FOR PERCOLATION TESTING AND SITE EVALUATION

Lot 27 Perc Cert Revision, 2/23/21

GREENBERRY SECTION II
GREENBERRY PRESERVATION PARCELS 'I', AND 'J', AND
NON-BUILDABLE BULK PARCEL 'K',
LOT # 26 AND 27, PARCEL 48, NON-BUILDABLE BULK PARCELS C AND G
TAX MAP 28, PARCEL 48, HOWARD COUNTY, MARYLAND
FIFTH ELECTION DISTRICT
REVISED PERCOLATION CERTIFICATION PLAN

GREENBERRY, SECTION II
LOTS 26 AND 27, NON-BUILDABLE PRESERVATION PARCELS 'I', AND 'J', AND NON-BUILDABLE BULK PARCEL 'K'.
TAX MAP 28, PARCEL 48, NON-BUILDABLE BULK PARCELS C AND G
HOWARD COUNTY, MARYLAND
FIFTH ELECTION DISTRICT
REVISED PERCOLATION TEST PLAN

Lot 26 Perc Cert Revision, 9/1/2020

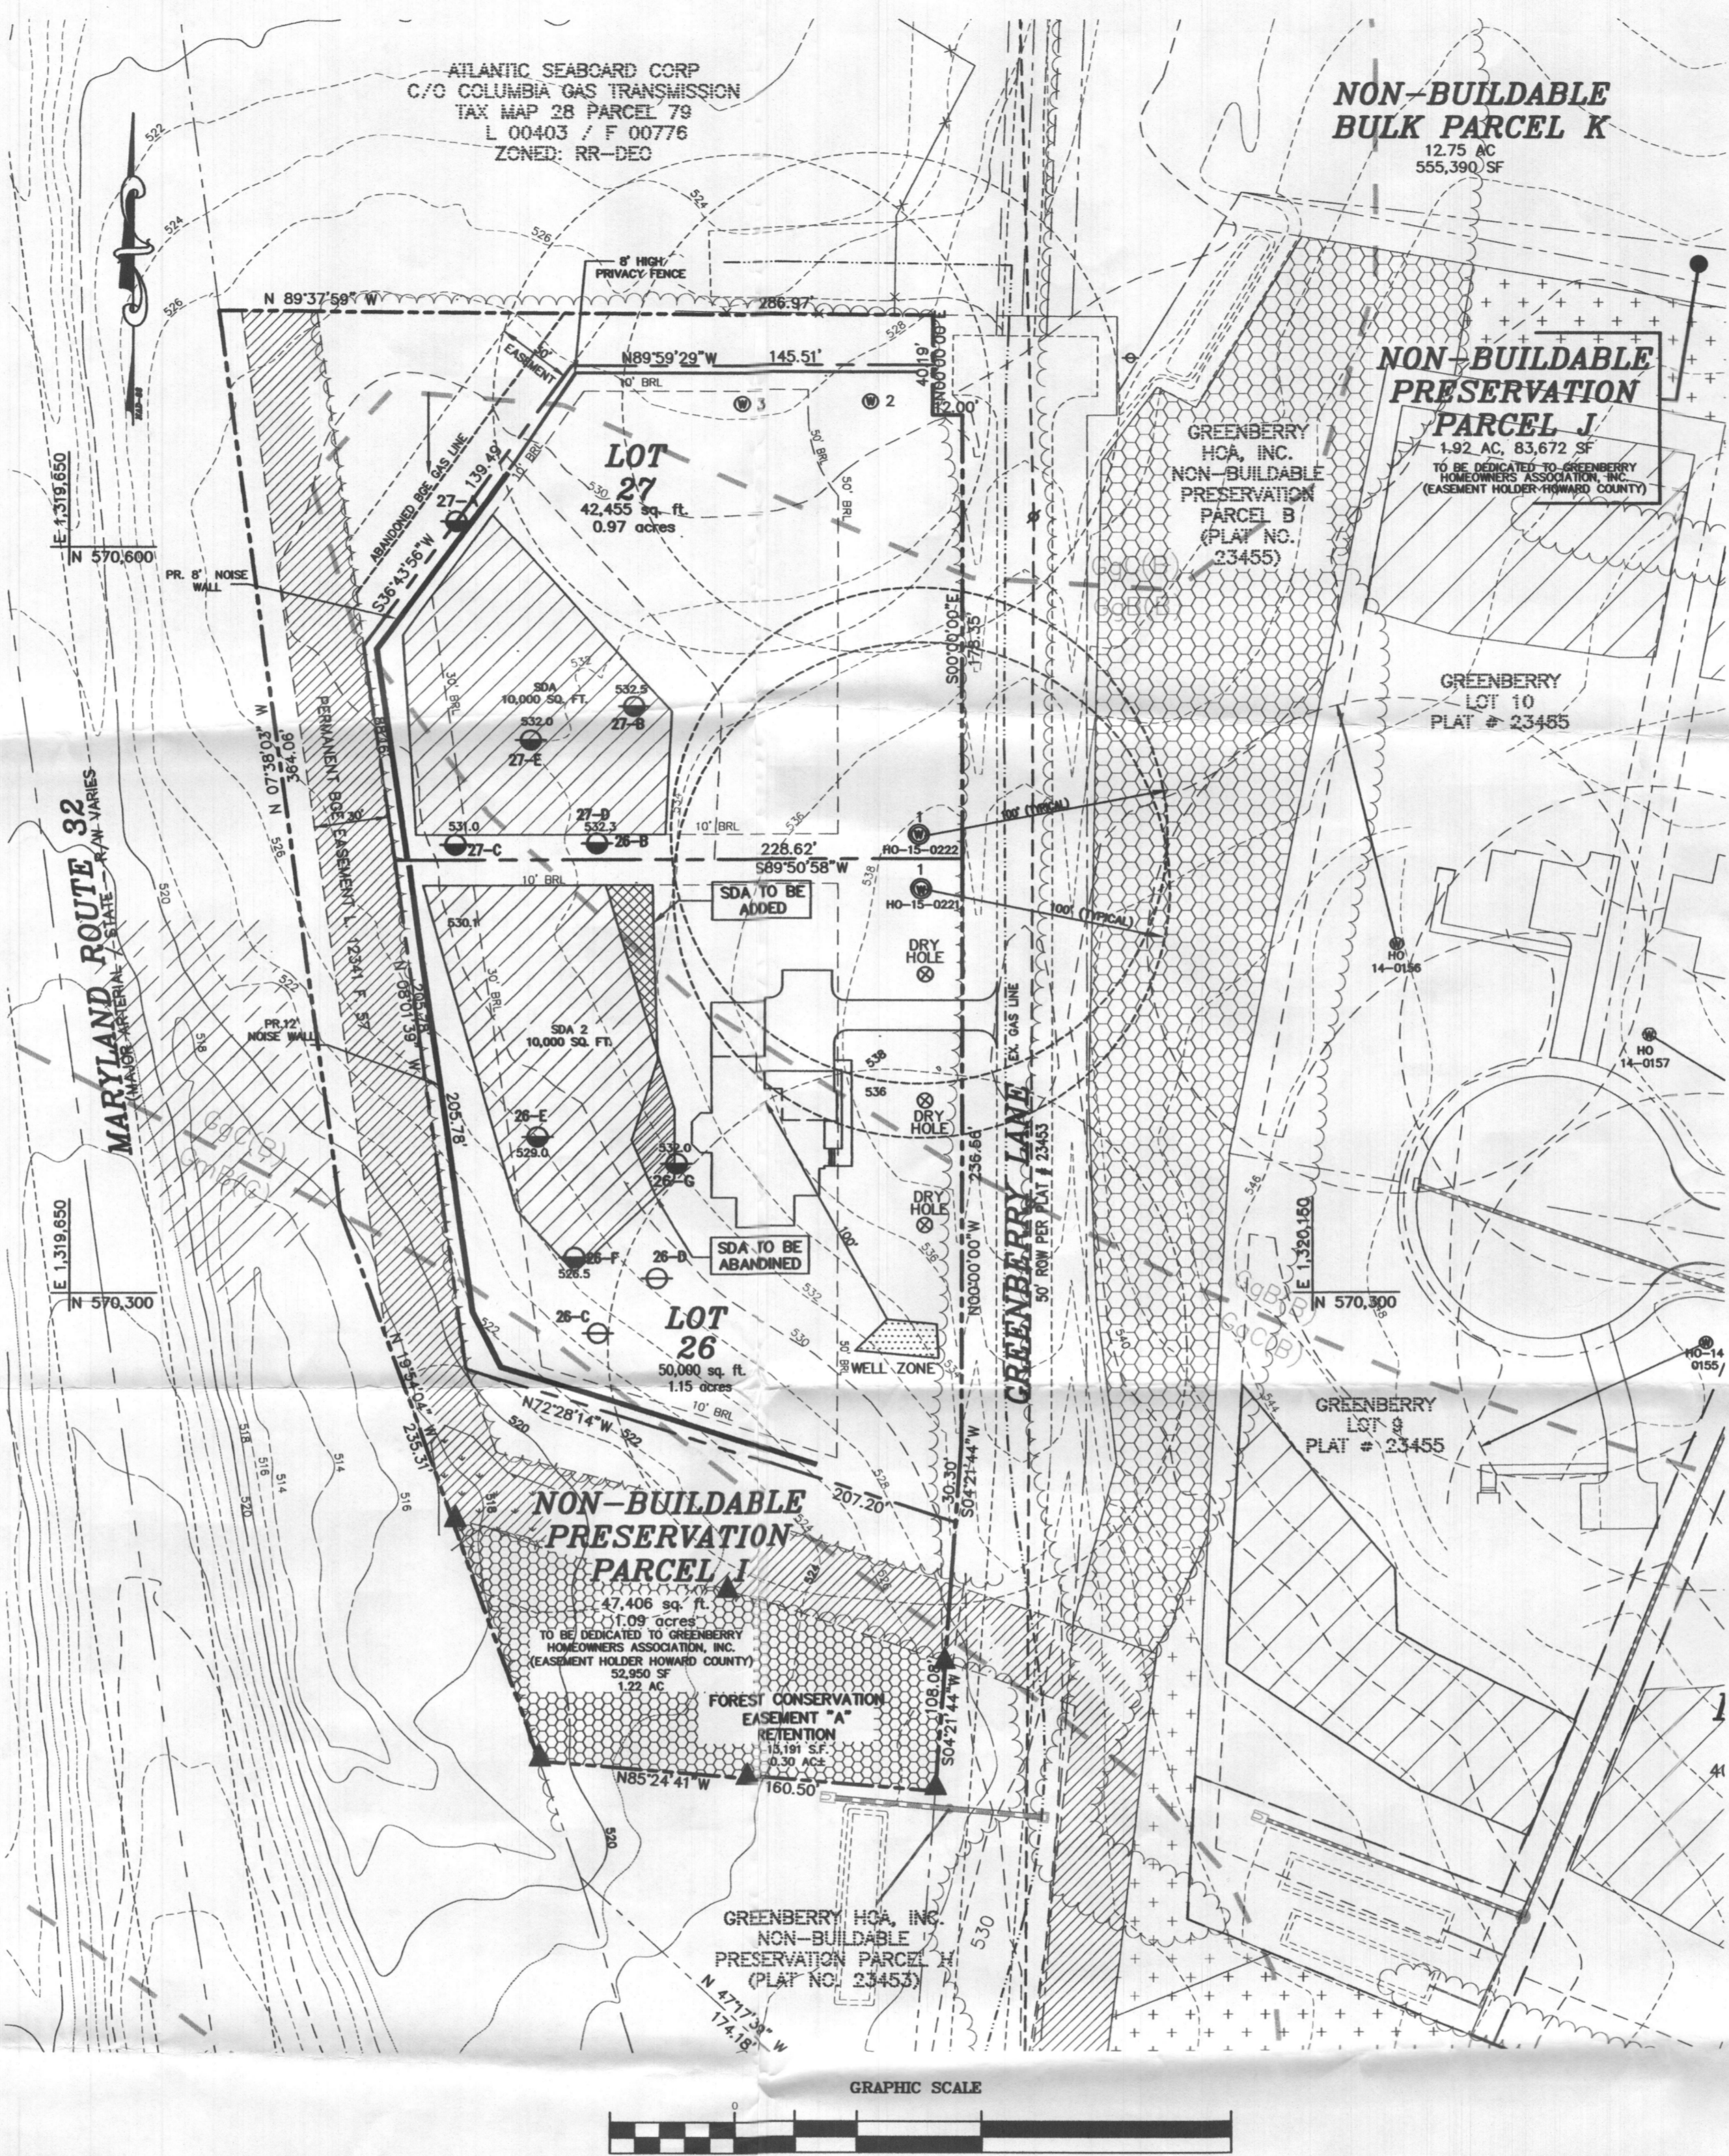
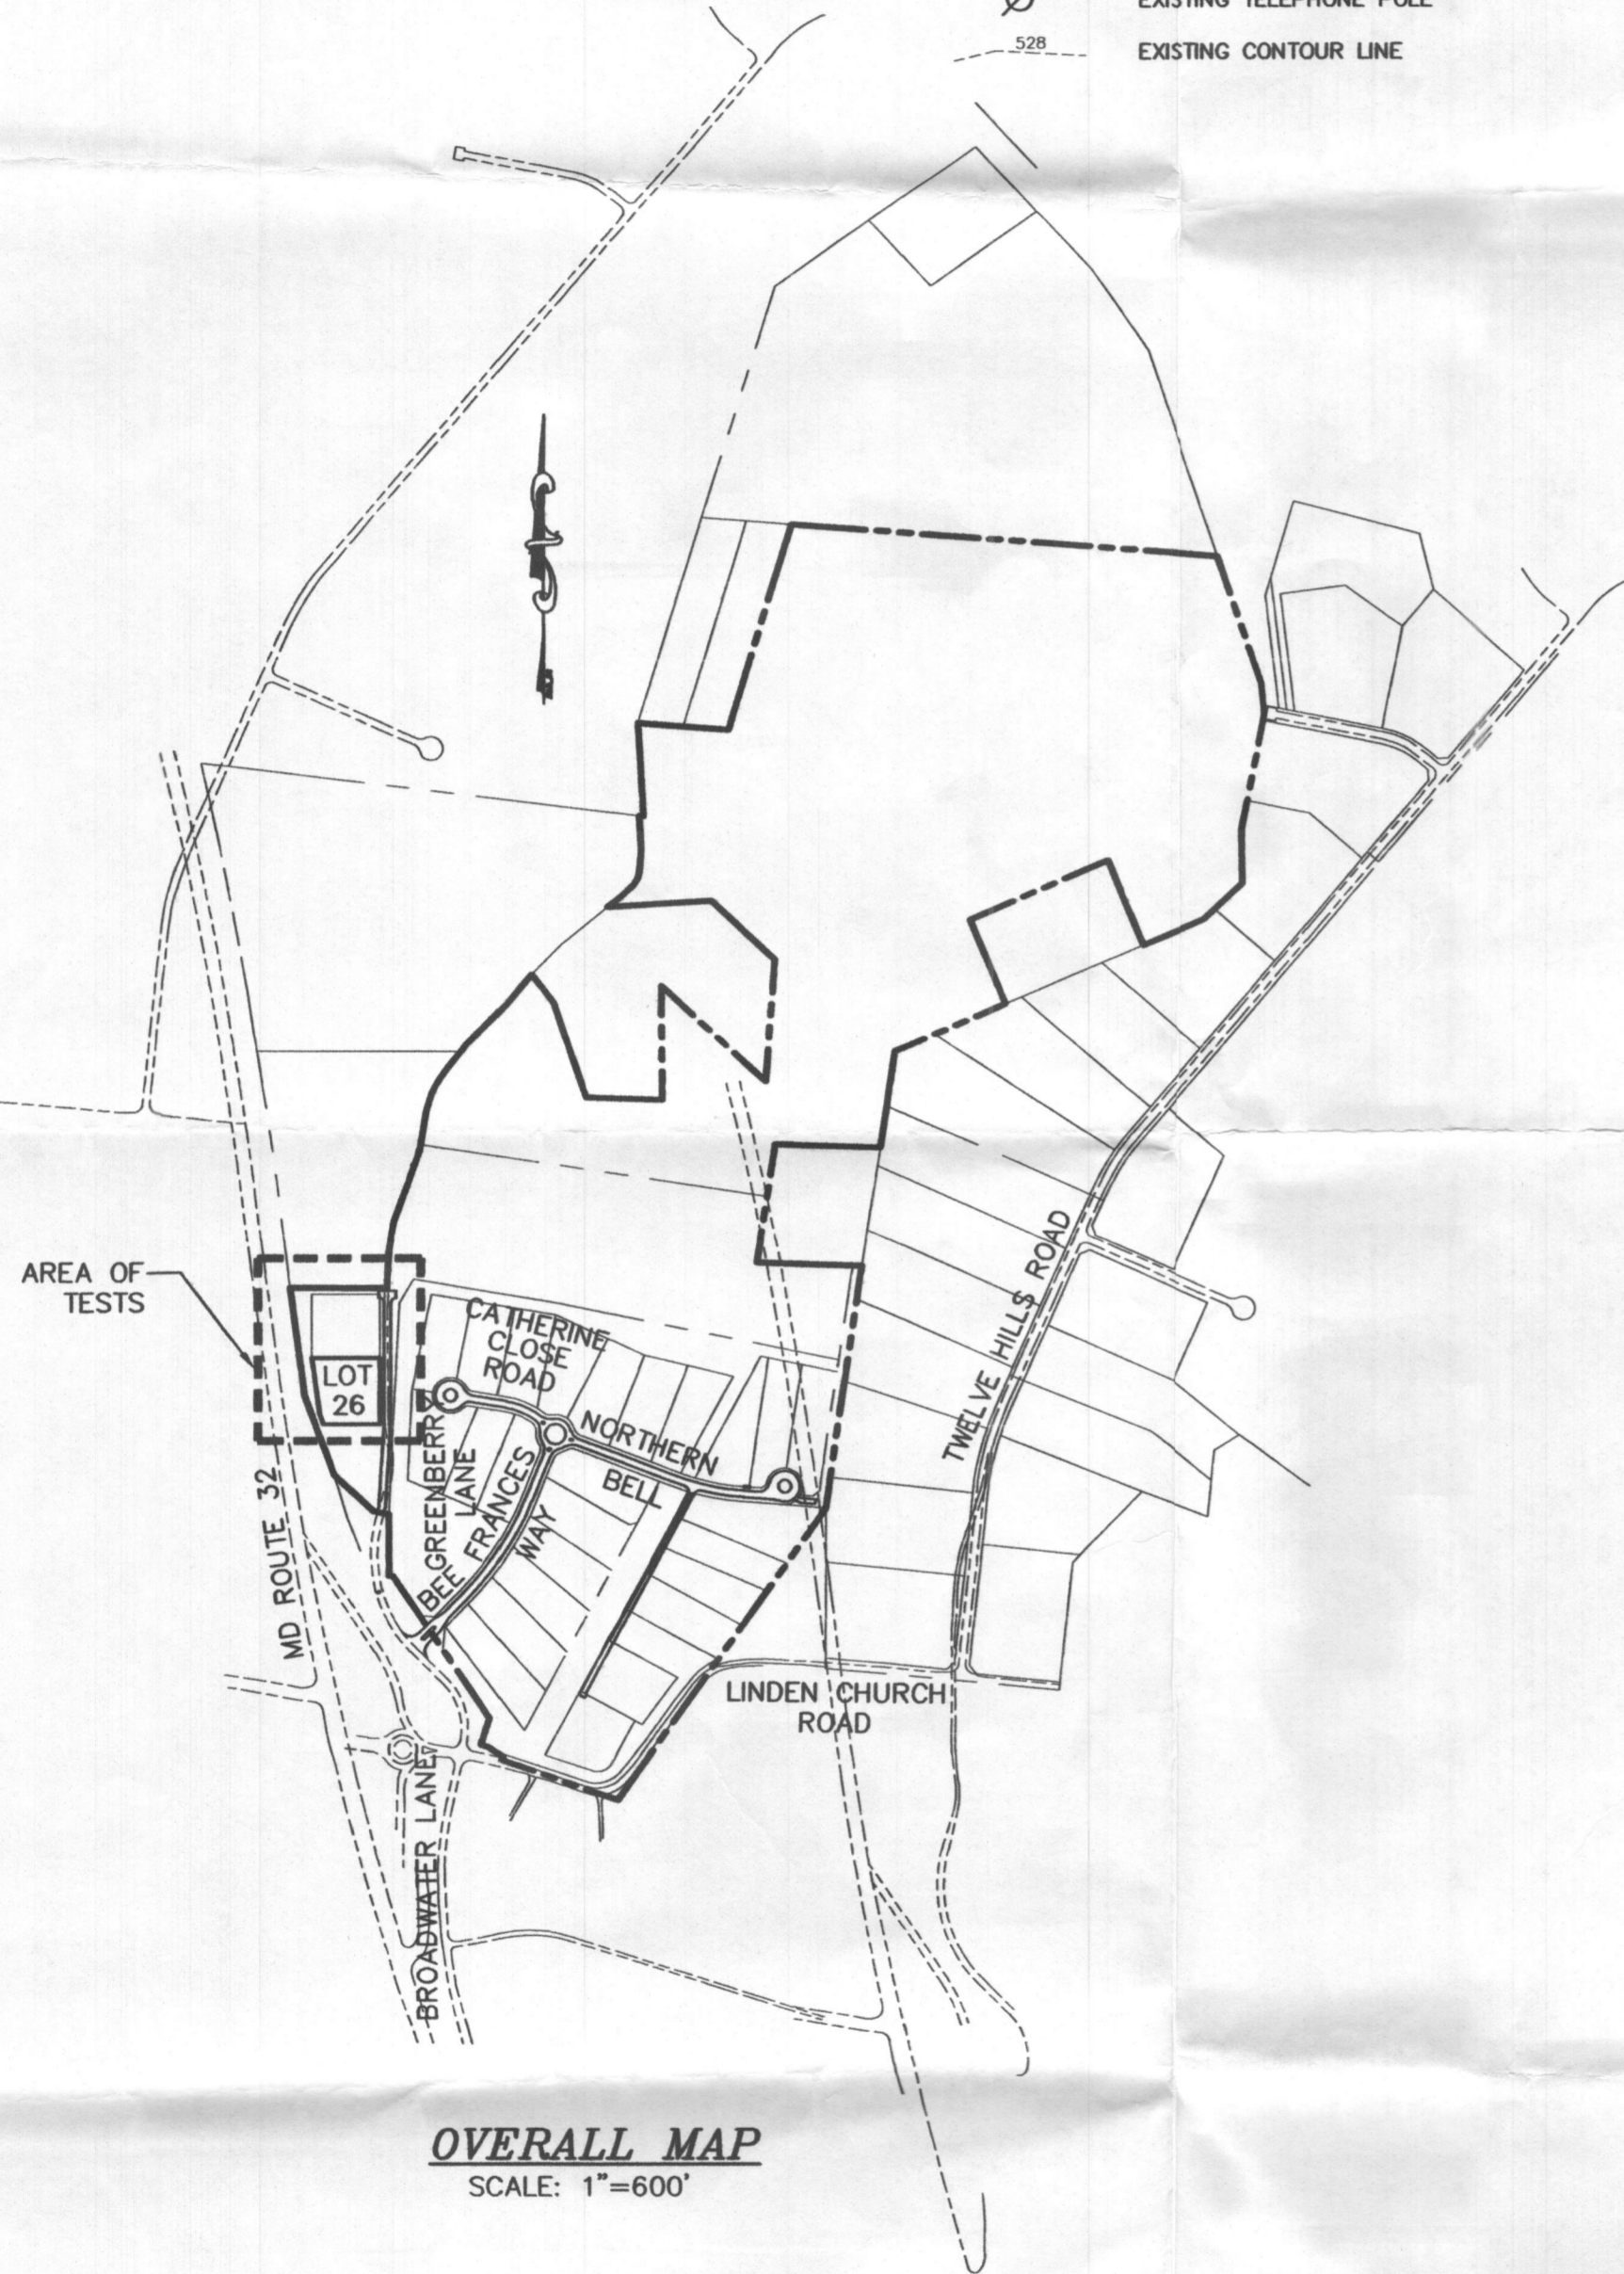
THE PURPOSE OF THIS REVISED PERC CERTIFICATION PLAN IS TO RECONFIGURE SEWAGE DISPOSAL AREA ON LOT 26

Lot 26 Perc Cert revision
9/1/2020

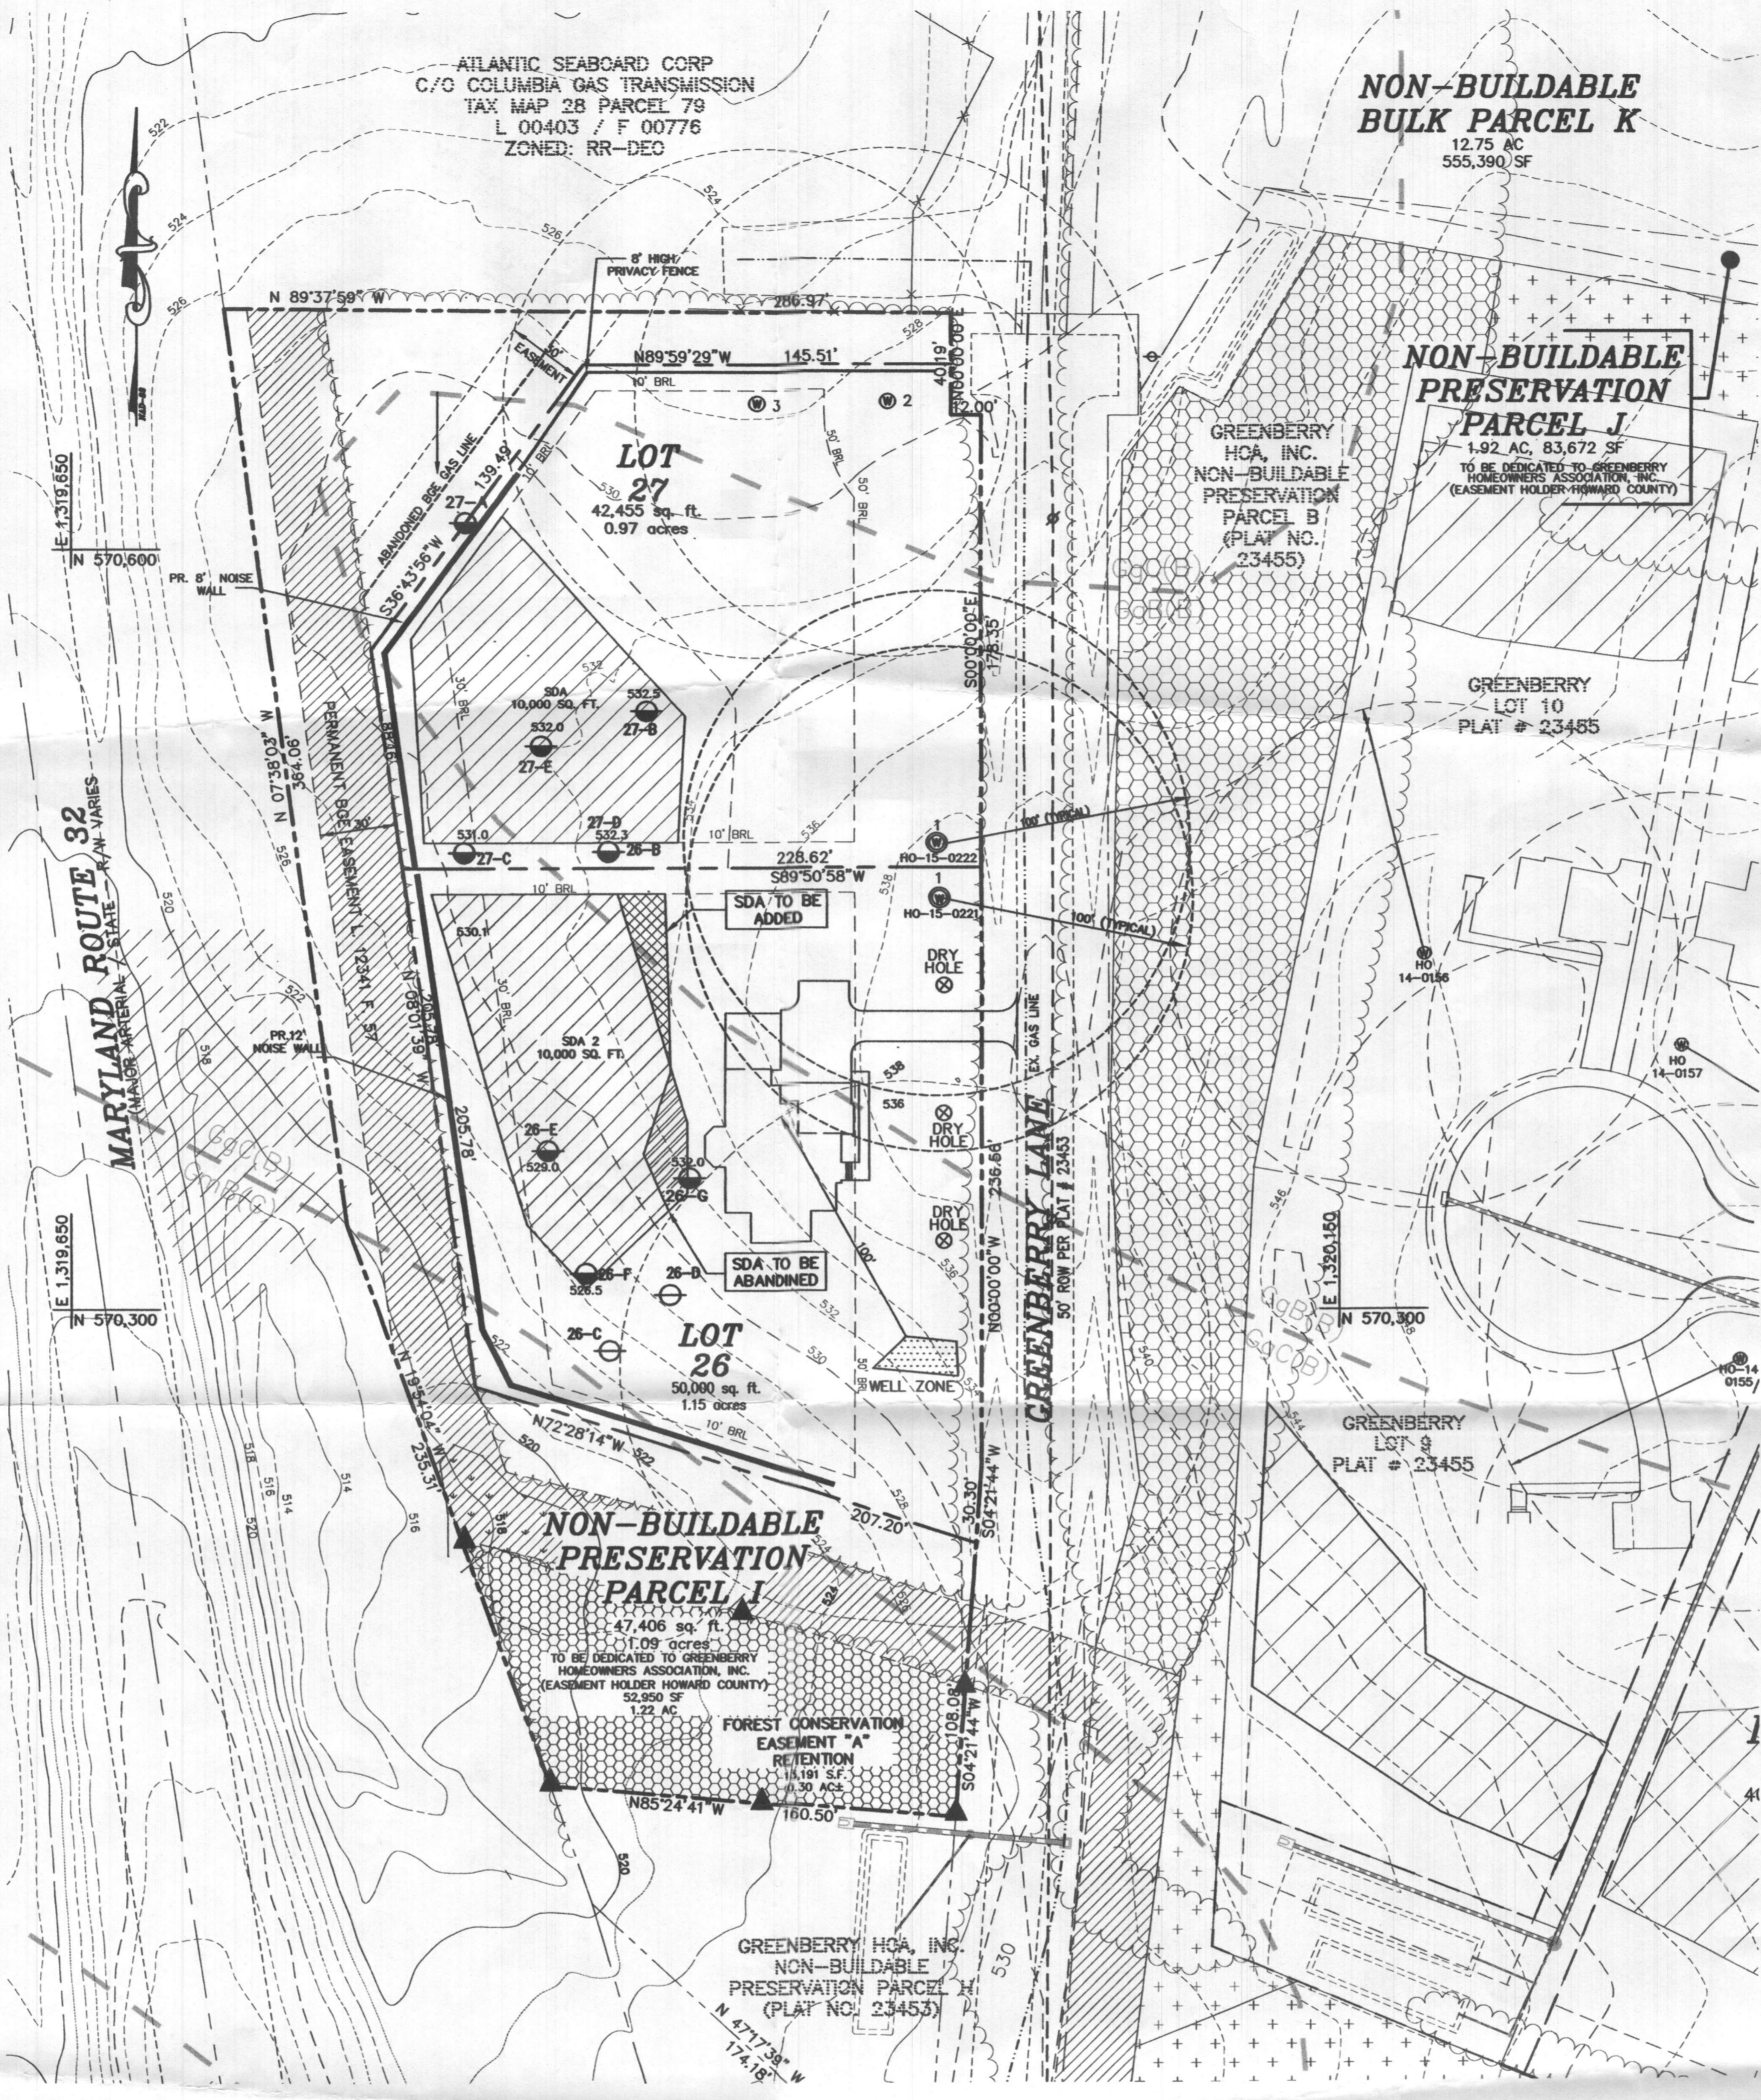
THE PURPOSE OF THIS REVISED PERC CERTIFICATION PLAN IS TO RECONFIGURE SEWAGE DISPOSAL AREA ON LOT 26
